# Construction Quality Assurance Report

## Harnett County Anderson Creek C&D Landfill - Phases I & II Extension Spring Lake, North Carolina

Permit No.	Date	Document ID No.
43-03	November 17, 2014	22287

**RE: Harnett County Anderson Creek C&DLF - Phases I & II Extension (Permit No. 43-03)  
Response to Review Comments**

**MOISTURE-DENSITY RELATIONSHIP**

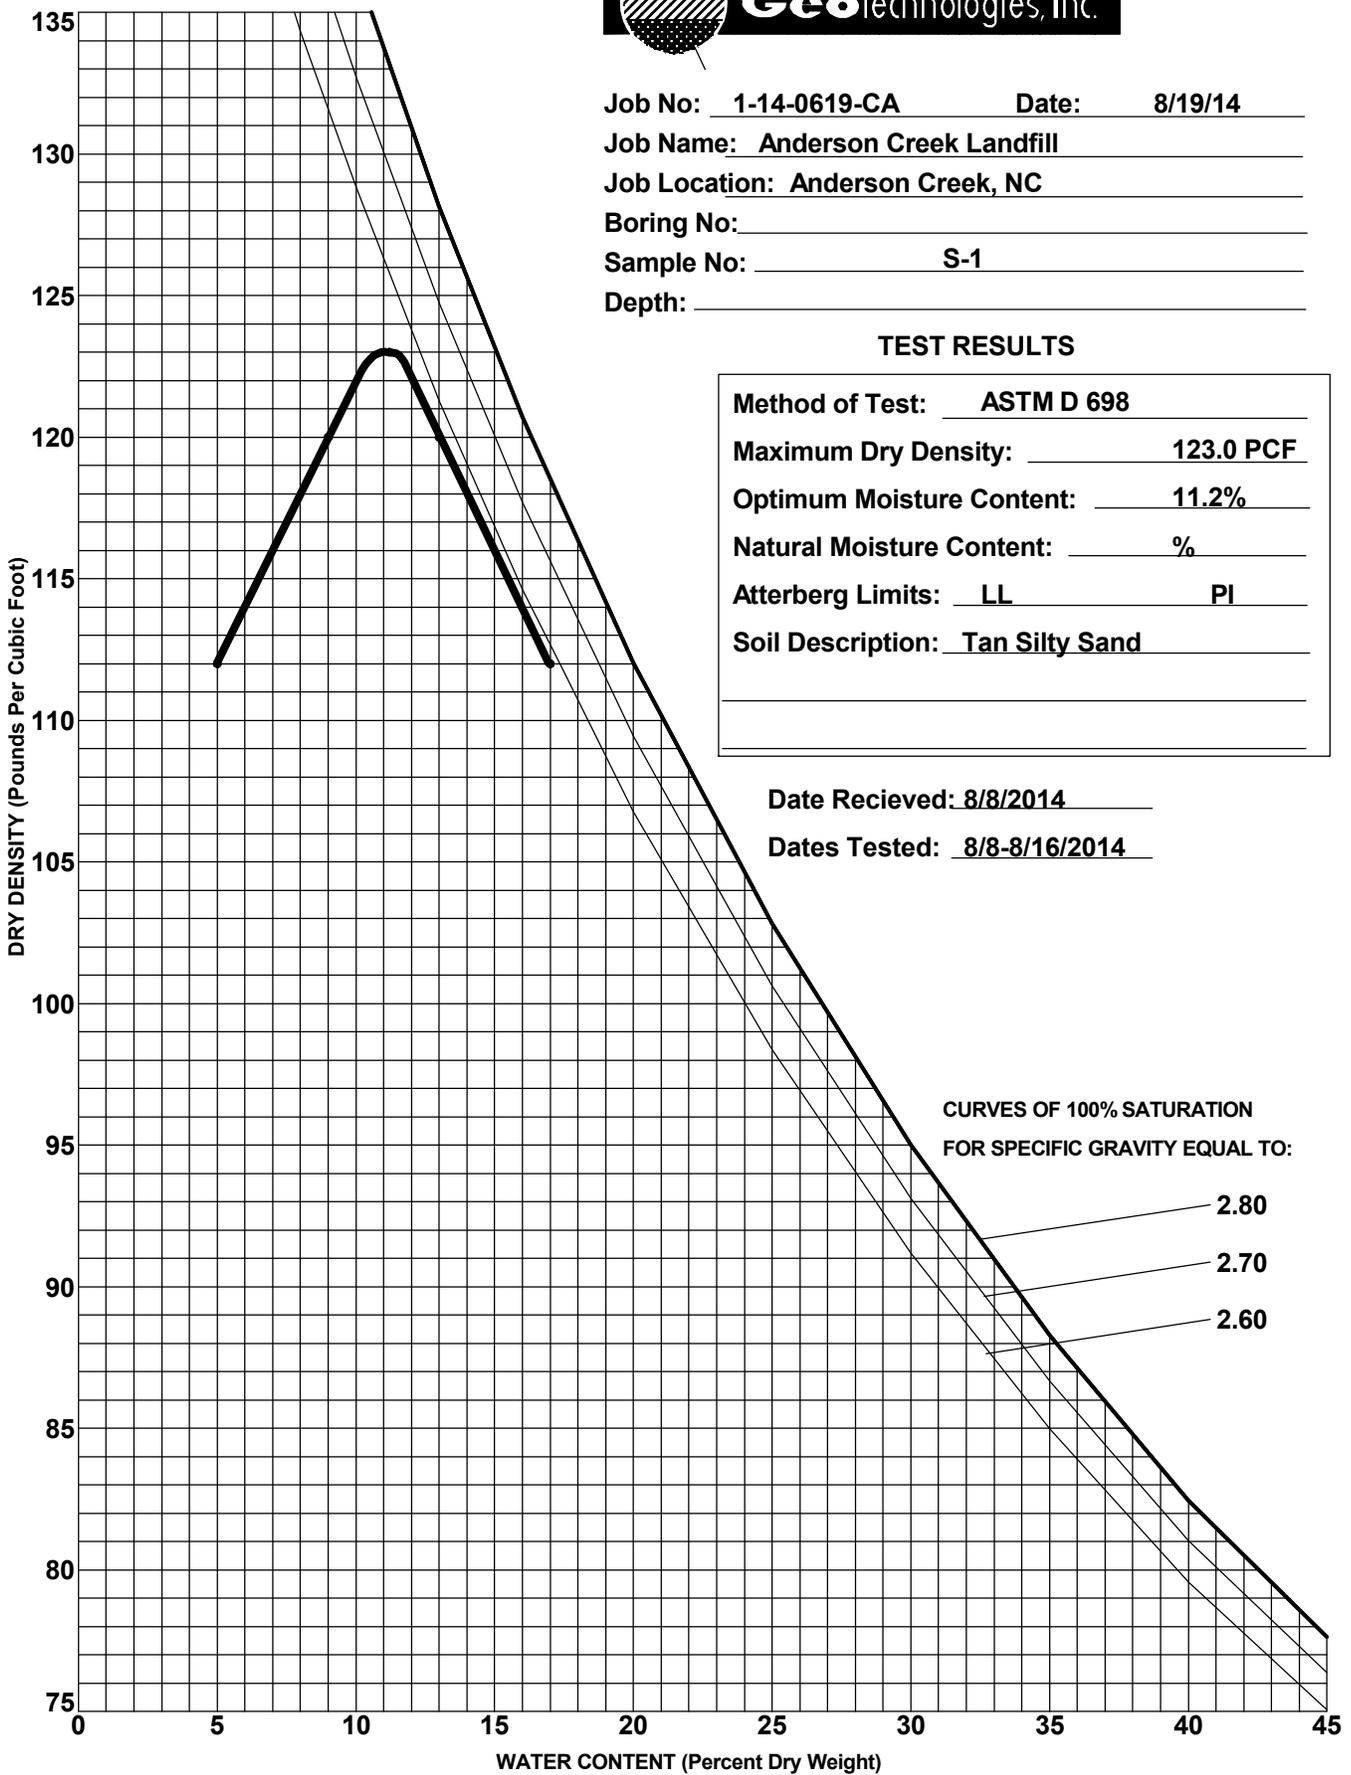
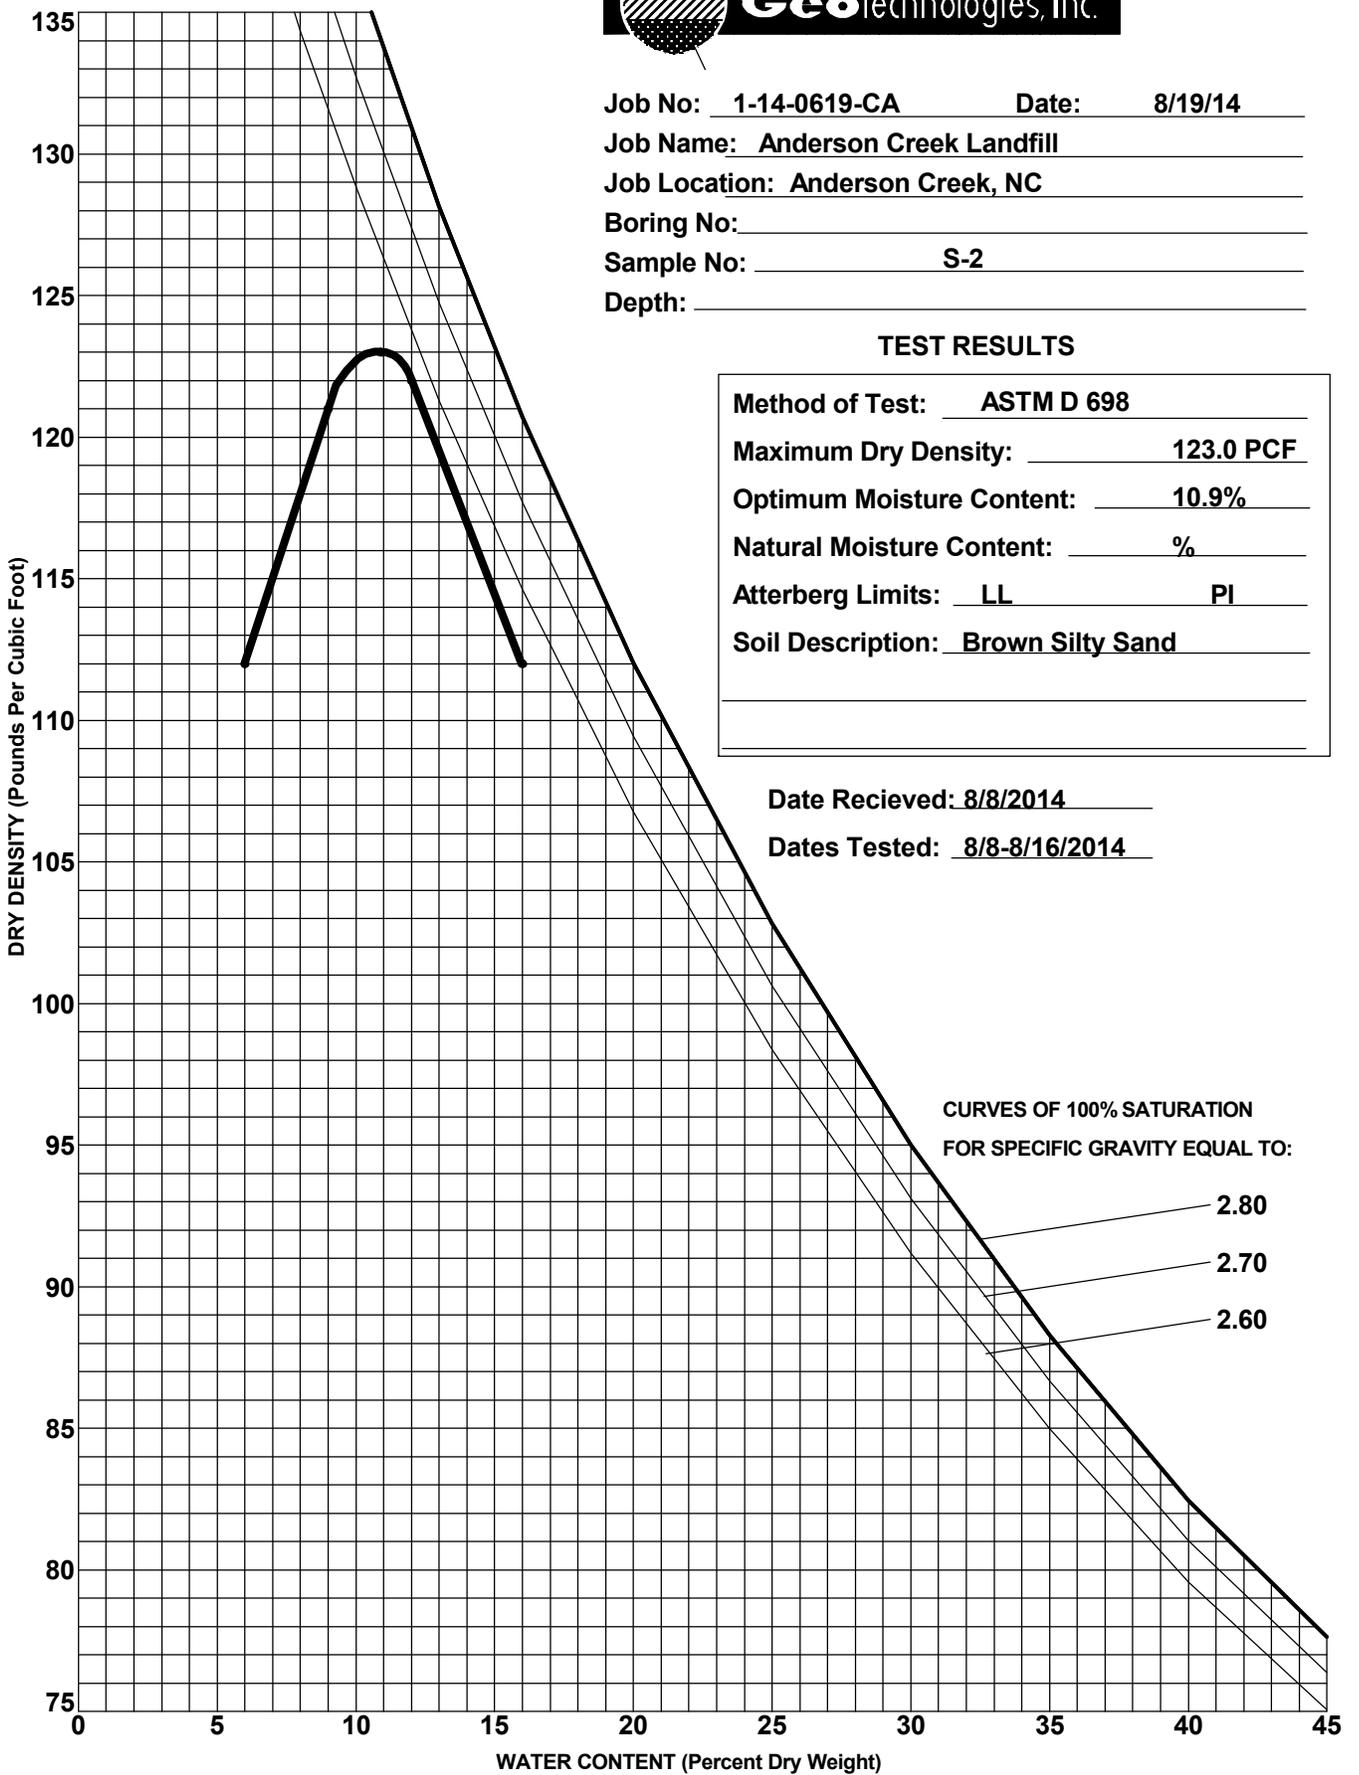
3. *(Appendix C) Pursuant to Section 3.1 - Embankment Material Approval of the approved CQA Manual, please provide the raw data & drawings that are used to determine the density and moisture relationship (according to ASTM D 698) of soil borrow used for this project.*

**Two laboratory standard Proctor (ASTM D 698) curves have been added to Appendix C. Note that the maximum dry density values differ slightly from the**

one-point Proctor information provided on the field test forms. Per Geotechnologies, their technicians perform one point Proctor tests in the field when performing in-place density testing. The one point is plotted in relationship to the closest laboratory Proctor curve for the project. The technician then uses the maximum dry density from the plotted one point, instead of the actual proctor curve maximum dry density. Geotechnologies' experience is that this provides a more accurate measure of the % compaction of the material as tested.

FIGURE NO. AB-1

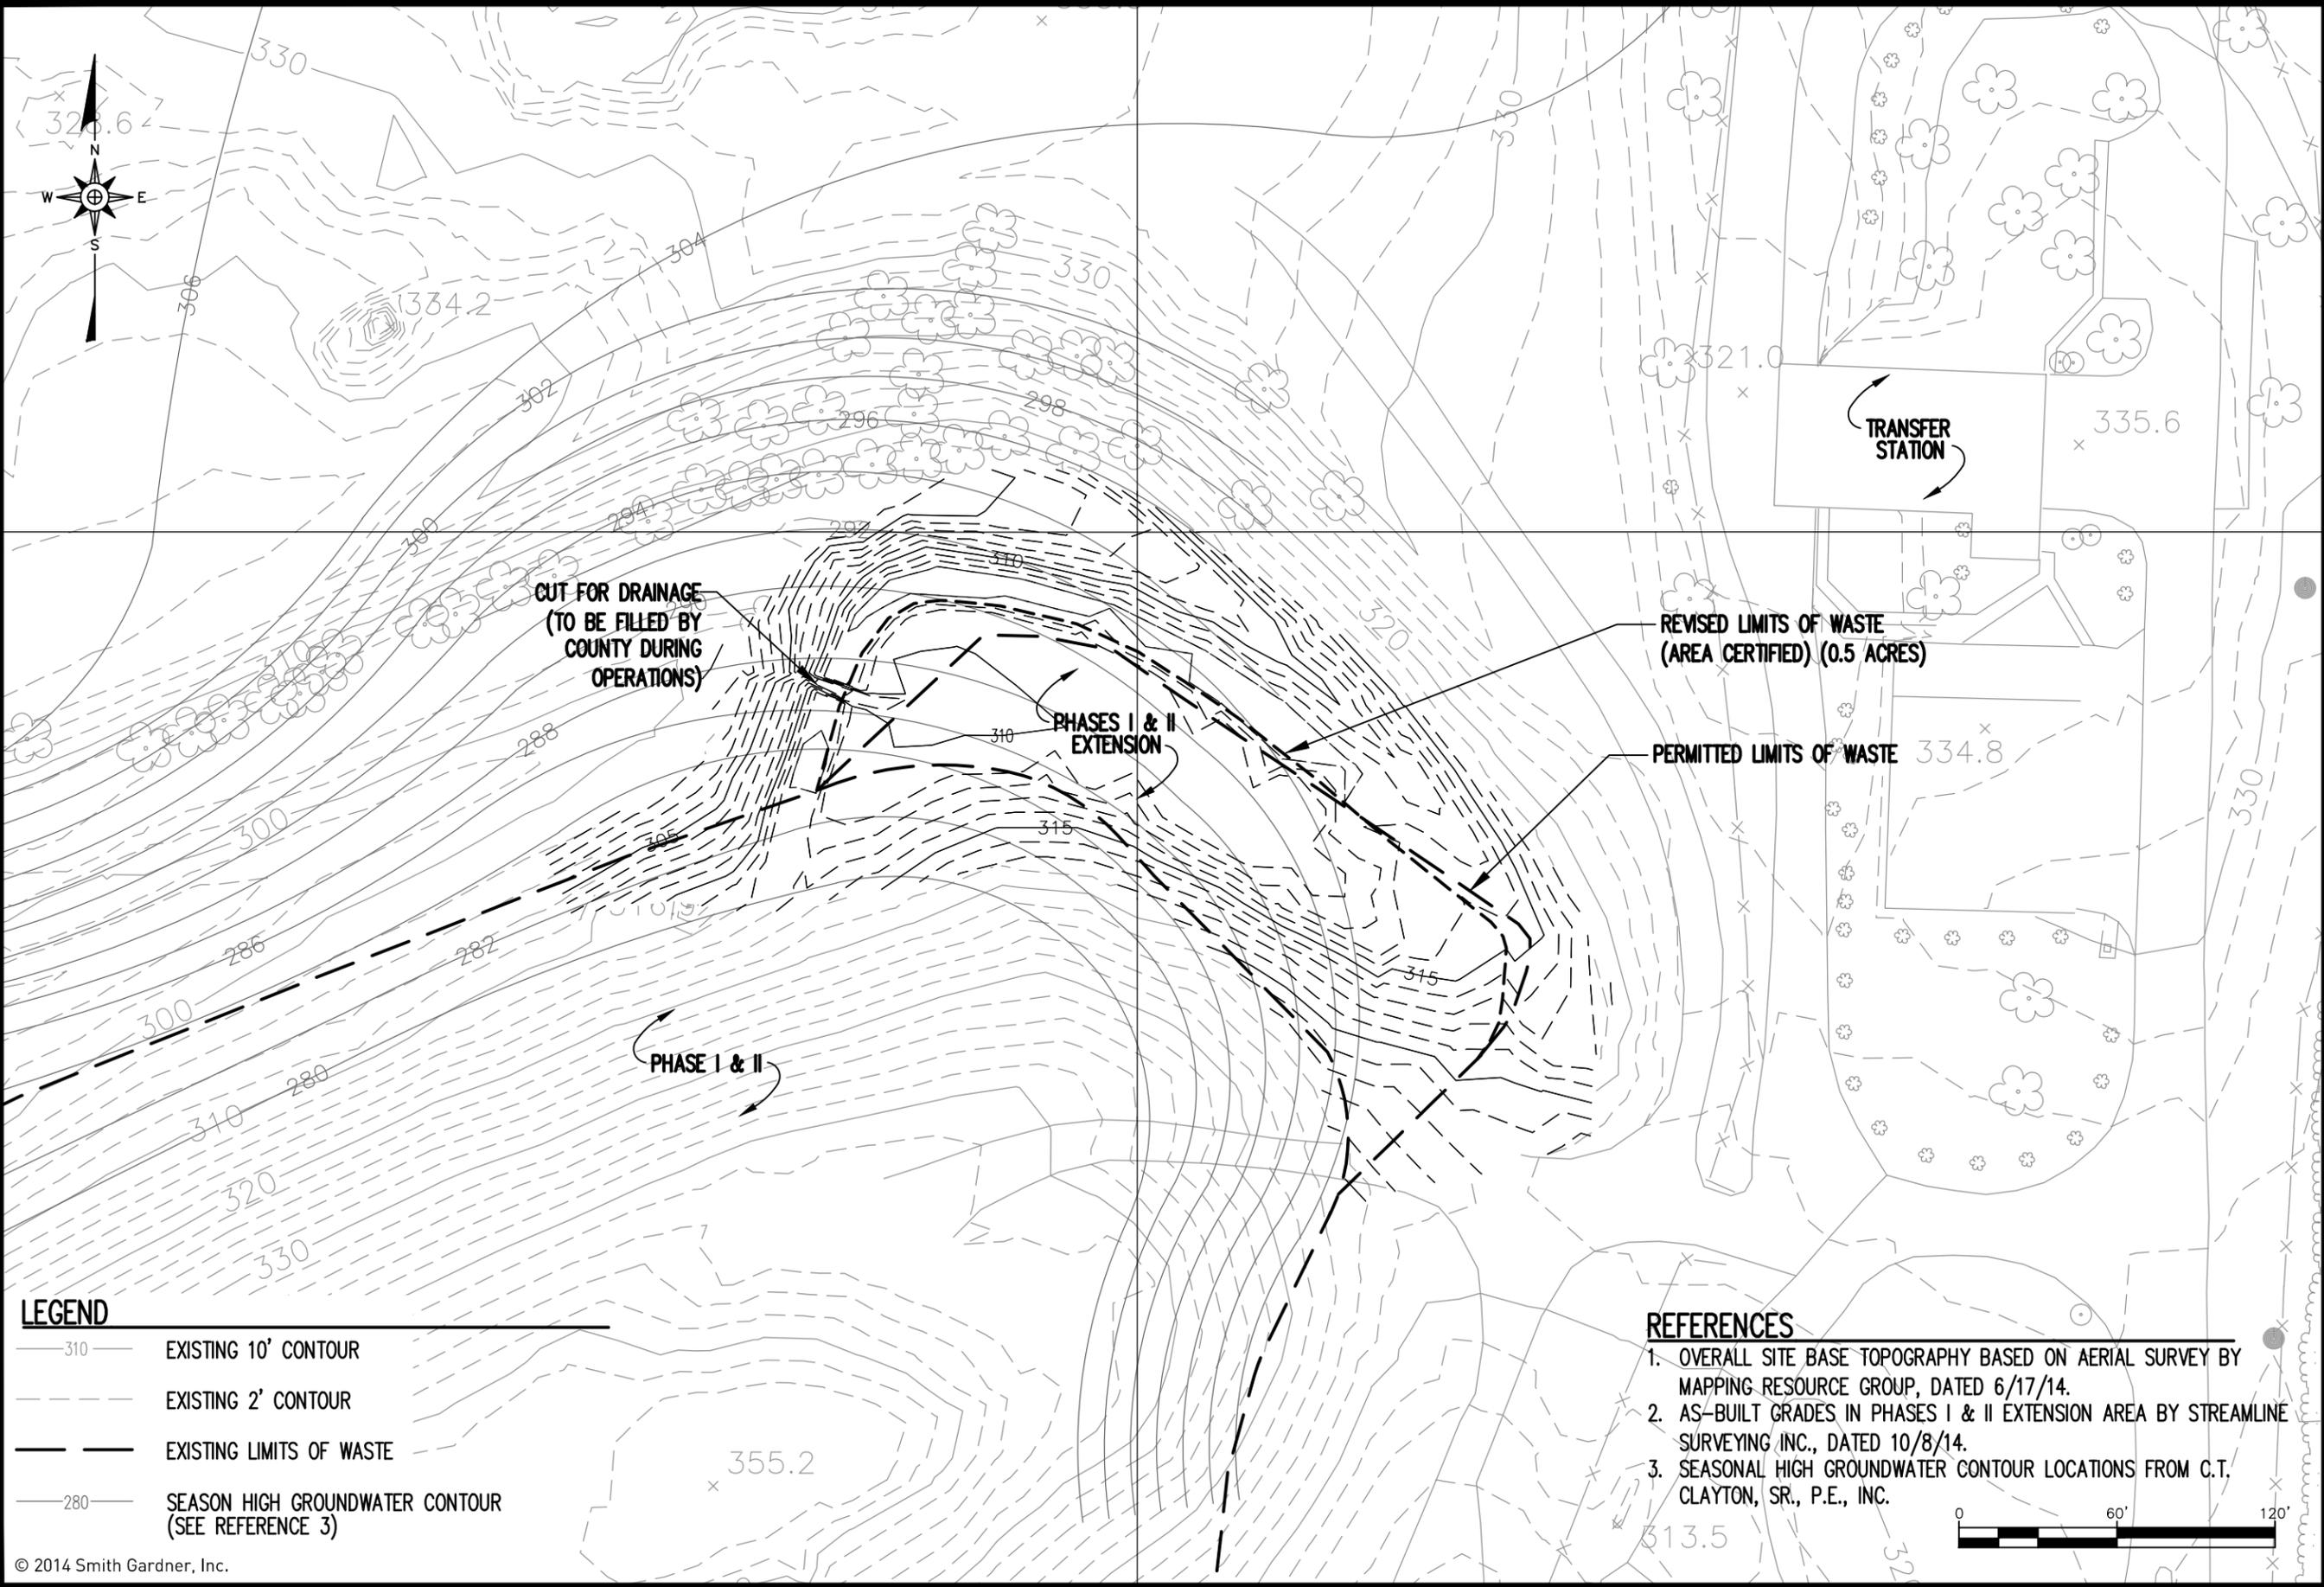
1. *(Section 2.1) Since the constructed berm deviated from the originally approved limits, please address the following concerns:*
  - i. *Please provide the final acreage of the Phase I & II Extension (Area Certified) shown on Figure No. AB-1.*
  - ii. *Please update data (waste footprint, capacity values, etc.) in Table 1 - Total Operating Capacity and Life Expectancy, Facility and Engineering Plan of the approved Permit Application dated January 2014 and revised March 2014 (DIN 20704).*

**Figure AB-1 has been revised to include the acreage (0.5 acres) and is included as part of the enclosed revised CQA report. Table 1 of the Facility and Engineering Plan is attached with the revised values.**
